Regulation No. 7 (Position, stop and end-outline lamps)

Proposal for Supplement 22 to the 02 series of amendments to Regulation No. 7 (Position, stop and end-outline lamps)

Submitted by the expert from China*

The result of simulation for light source P21/4W by software:

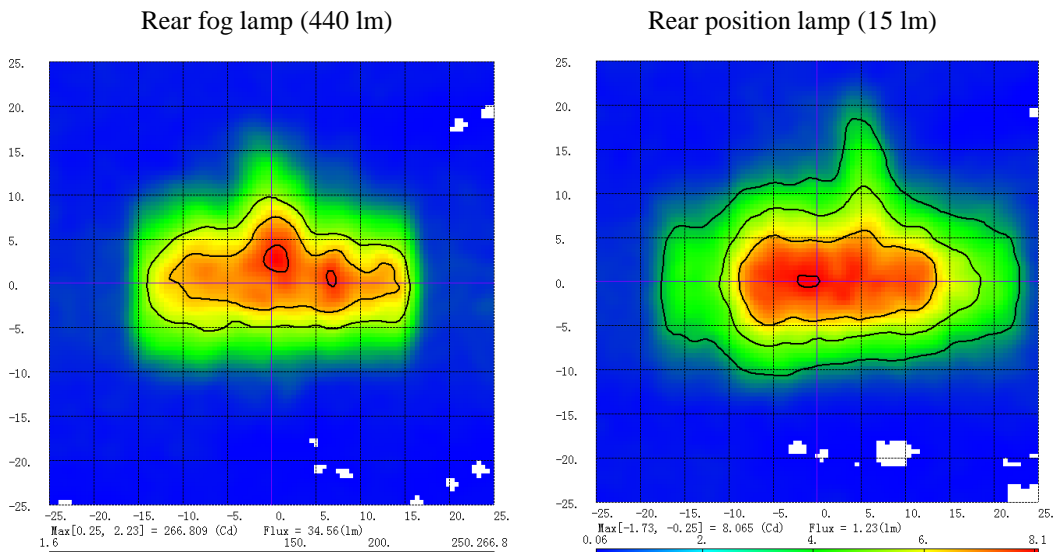
9. The simulation indicates that rear fog lamp has a maximum intensity of 266.8 cd and rear position lamp has a maximum intensity of 8.1 cd. According to the ratio of luminous flux of the two filaments, the maximum intensity of rear position lamp should be 9.1 cd, but it is simulated to be 8.1 cd. The reason is that the main filament is positioned and the second filament is not positioned in the focus of the reflector.
